DOCKETED	
Docket Number:	12-AFC-02C
Project Title:	Huntington Beach Energy Project - Compliance
TN #:	206921
Document Title:	Presentation - Petition to Amend Huntington Beach Energy Project Visual Resources
Description:	Visual Resources Presentation - HBEP Amendment Data Request Workshop
Filer:	Cathy Hickman
Organization:	California Energy Commission
Submitter Role:	Commission Staff
Submission Date:	12/10/2015 1:37:16 PM
Docketed Date:	12/10/2015

Petition to Amend Huntington Beach Energy Project Visual Resources

Figure 1.

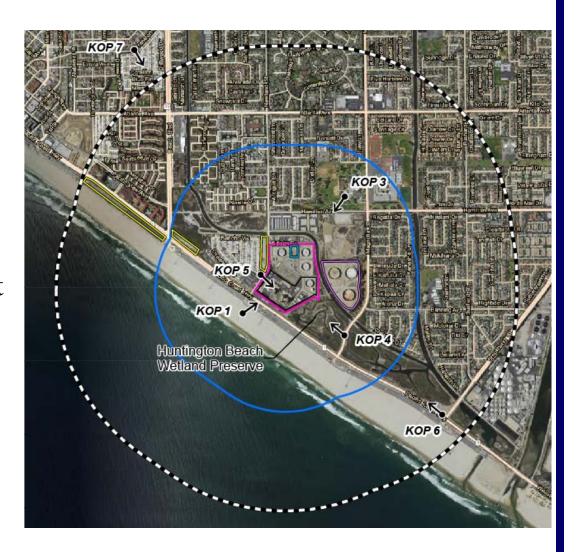
- ❖ KOPs closest to the HBEP site include views from Huntington State Beach, Magnolia Street next to Magnolia Marsh, and Newland Street (KOPs 1, 4, and 5; **Figure 1**).
- ❖ Project is in the Coastal Zone near the Pacific Coast Highway. Development must restore and enhance visual quality in visually degraded areas where feasible (Coastal Act § 30251).
- ❖ Commission's Final Decision requires visual mitigation that is consistent with the architectural enhancements recommended by the City of Huntington Beach. The Decision includes figures showing the conceptual architectural enhancements at the KOPs.
- ❖ Applicant's amendment petition and data responses do not provide revised conceptual architectural enhancements for the project.

Key Observation Points within a Half-Mile of the HBEP Site (inside the blue line). KOP 3 does not provide a direct view of the project due to its greater distance to the site and other development between the viewpoint area and the project site.

Figure 6. KOP 5 – Licensed HBEP With Architectural Enhancements

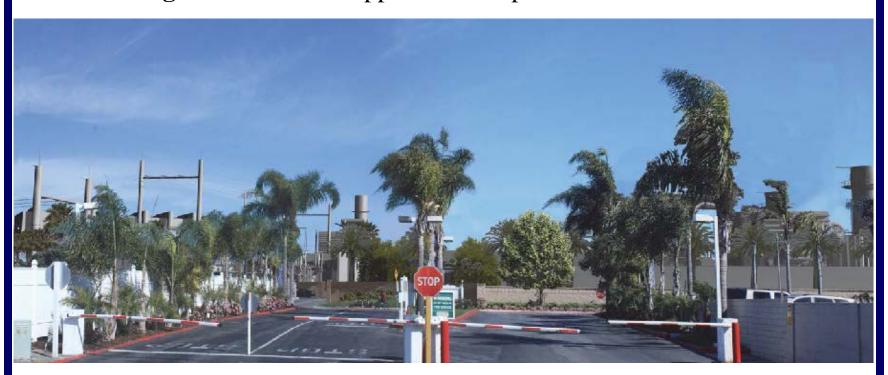
- ❖ For KOP 5 at Newland Street, **Figure 6** shows the licensed project with the City's recommended architectural screening concept (Figure 12 in the Commission Decision).
- ❖ Under the amended project, the arrangement of the simple-cycle power blocks on the site would make major project structures less visible from this KOP (**Figure 7**).
- * The simple-cycle power blocks on the west side of the site would be clearly visible from viewpoints close to KOP 5, including nearby views from the Pacific Coast Highway.
- The architectural screening concept included in the Commission Decision applies to the whole project and not only to specific KOPs.
